Document Type: Change Order Memorandum
Subject: Change Order 11
Project: 0912-31-304; CR 58
Description: Retaining Wall Work on Sidewalk

Change Order No. 11 (CO 11) provides a new work item to construct a two foot tall retaining wall attached to the sidewalk at STA 77+94.52 to STA 80+50.00. This change order does not impact the critical path, therefore no time adjustments are made.

FED. RD. DIV. NO.	STATE	PROJECT NO.			HIGHWAY NO.
12	TEXAS	STP 1702 (437) MM			CR 58
STATE DISTRICT	COUNTY	CONTROL NO.	SECTION NO.	JOB NO.	SHEET NO.
HOU	BRAZORIA	0912	31	304	4

CR 58
FROM SAVANNAH DEVELOPMENT TO CR 48
ROADWAY PLAN & PROFILE
BEGIN TO STA 80+60

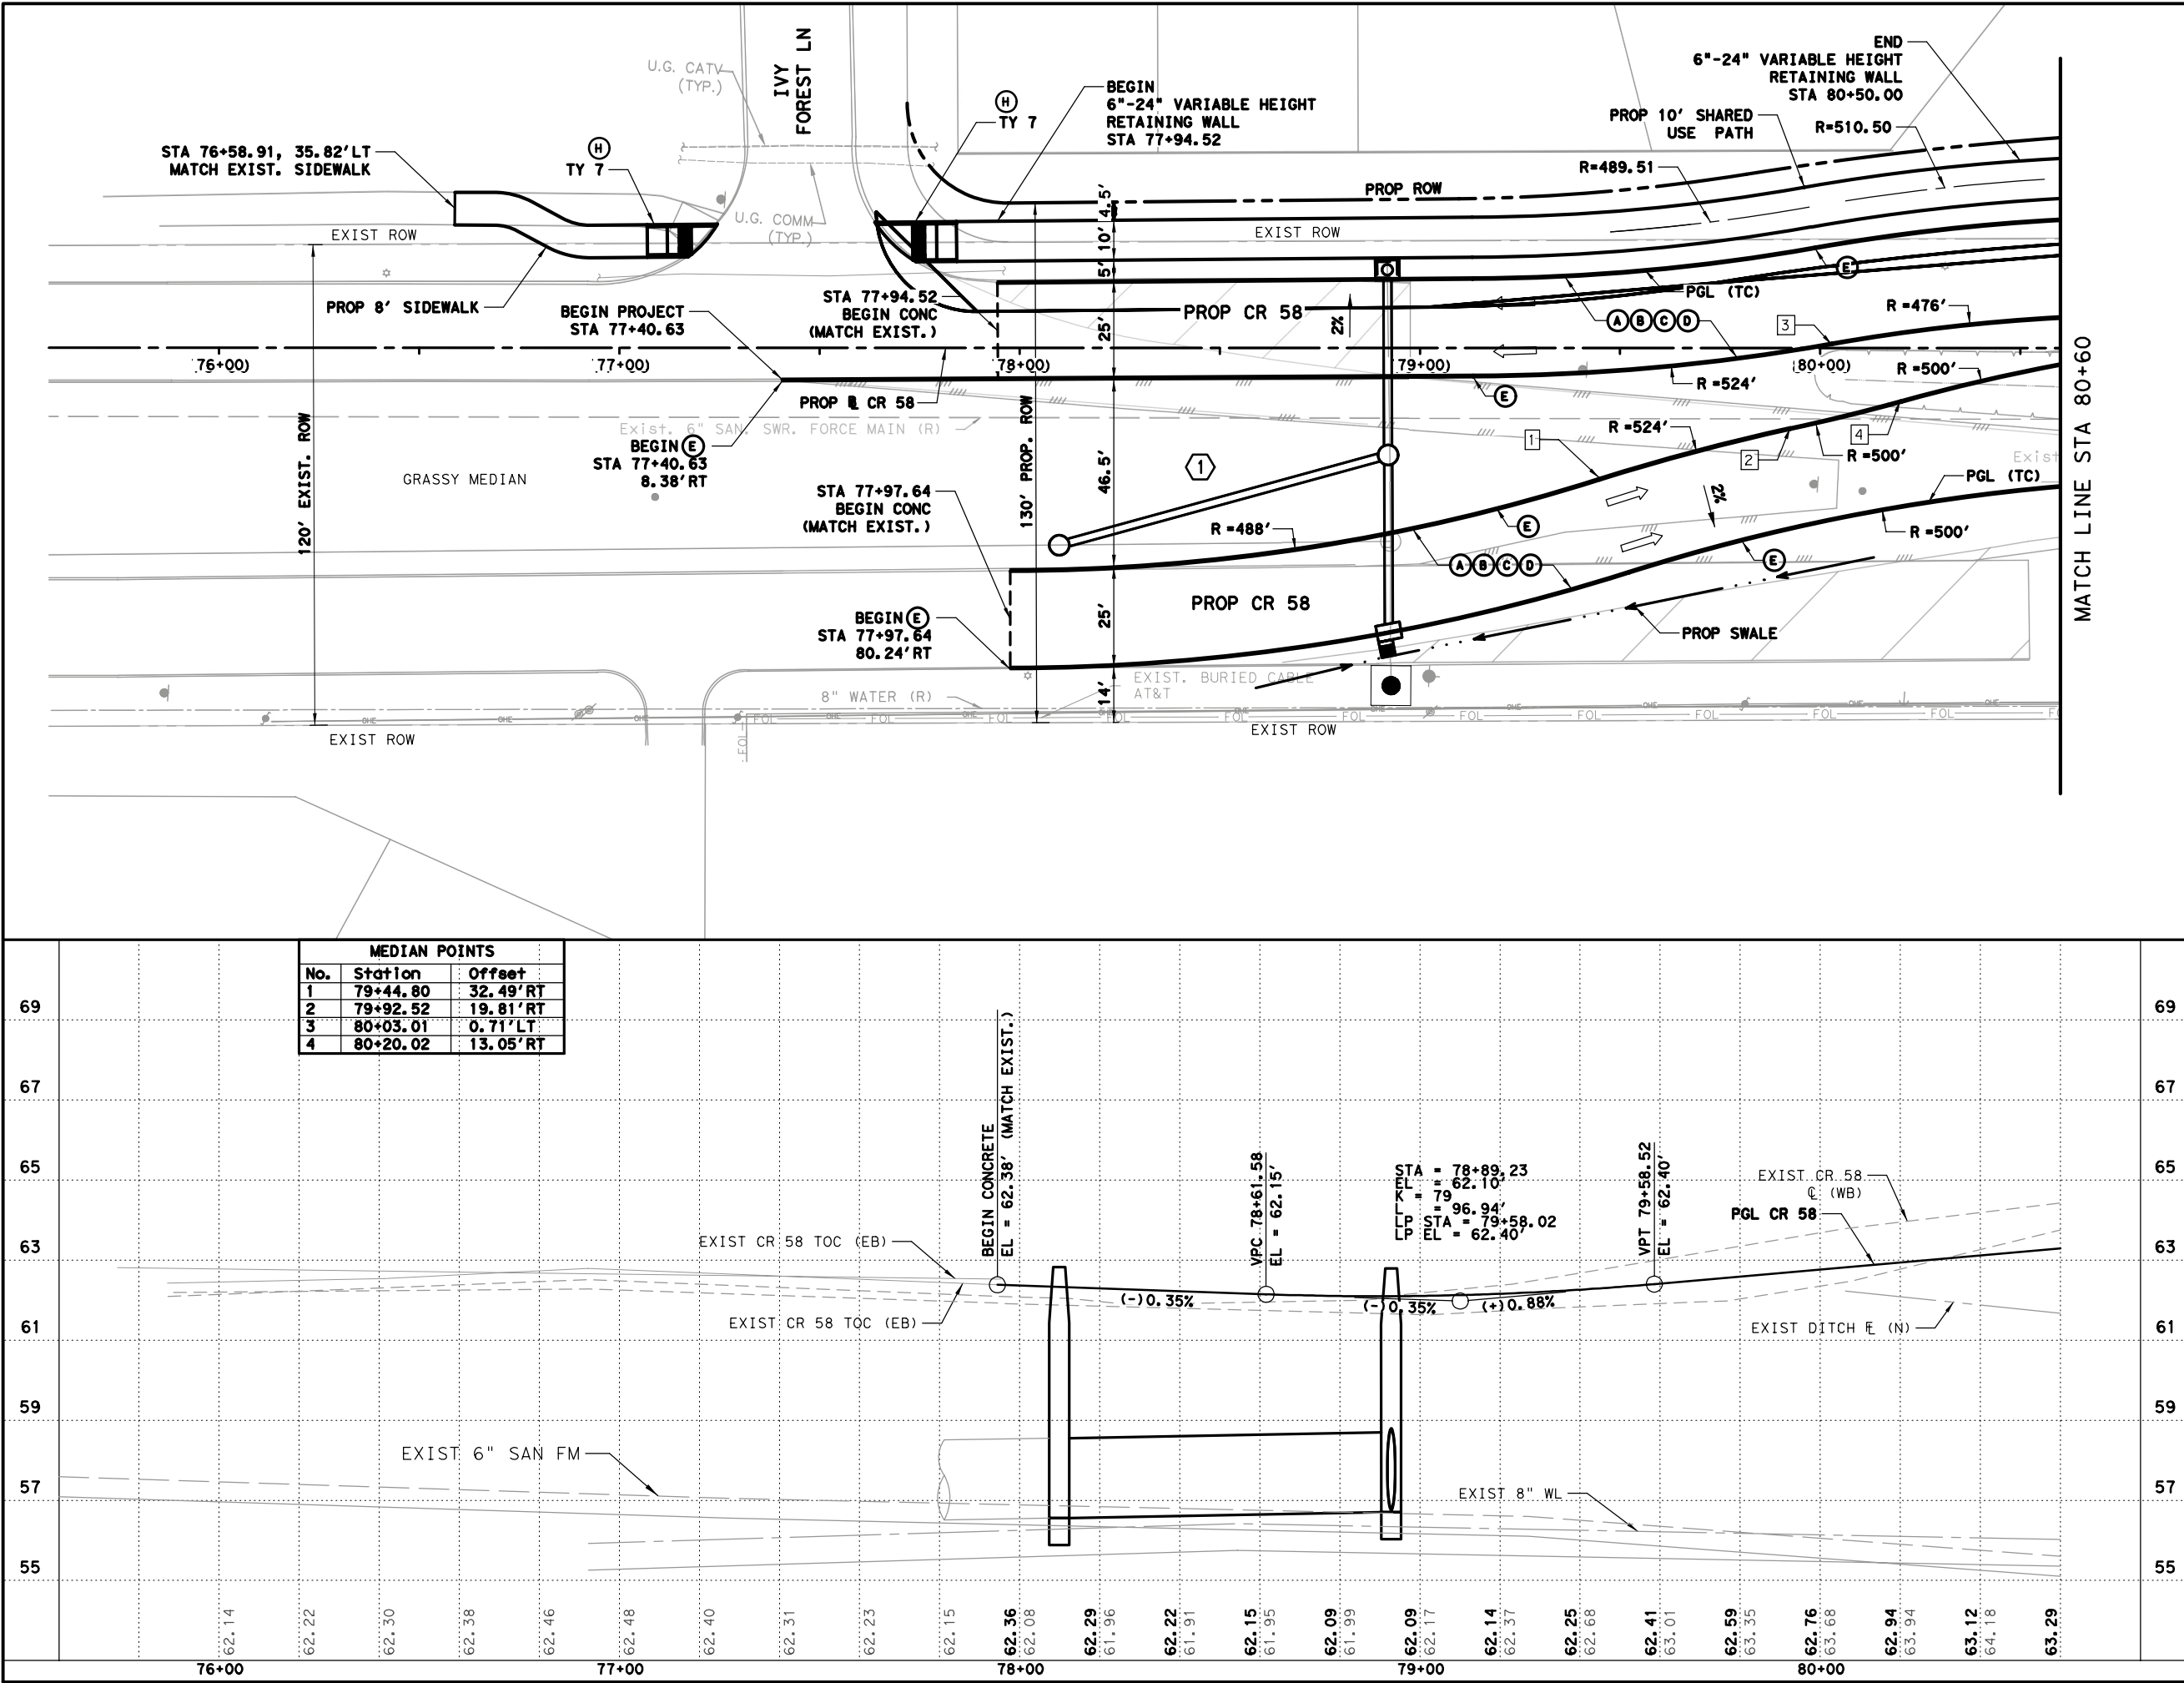
The CR 58 project was designed to have a small variable height retaining wall which attaches to the sidewalk between STA 77+95 and STA 80+50. This work is shown on plan sheet 66. The wall is designed to attached to the sidewalk through a footing and a thickened end to support the structure. This cross section is shown on the typical section plan sheet 4. These two plan sheets are attached to this change order for reference.

The retaining wall is required since the elevation at the Right-of-Way (ROW) line is approximately 3 feet higher than the sidewalk according to the design cross sections. The natural land then continues to rise after the ROW line with landscaping that is maintained by the local Homeowners association. This wall allows for a reasonable slope to be maintained both on and off the ROW at this location.

The contract plans do not show a specific work item for this retaining wall; Rather, the area is shown as the same sidewalk item as the remainder of the project. There is also no

notes stating that the work is subsidiary to the sidewalk. Therefore, this change order proposes to add item 529-6015 "CONC CURB (TY C1)" to complete the retaining wall.

I had met with ICON about the small retaining wall on the west end of the project. It is a 2' wall that holds the embankment for the Savannah Development landscaping where there is currently a cut. I attached the plan sheet cross section on sheet 4, it anchors with a footing that is attached to the sidewalk as one unit. I have done this before in other districts, since it is specialized compared to the rest of the sidewalk there is normally a different pay item.

The contractor has agreed to perform the work under the current statewide 12-month average low bid unit price, which is \$153.36/LF. Since this pricing is based on competitive bids around the state, this pricing is considered fair and reasonable. This change order will add a total of \$39,180.41 to the contract.
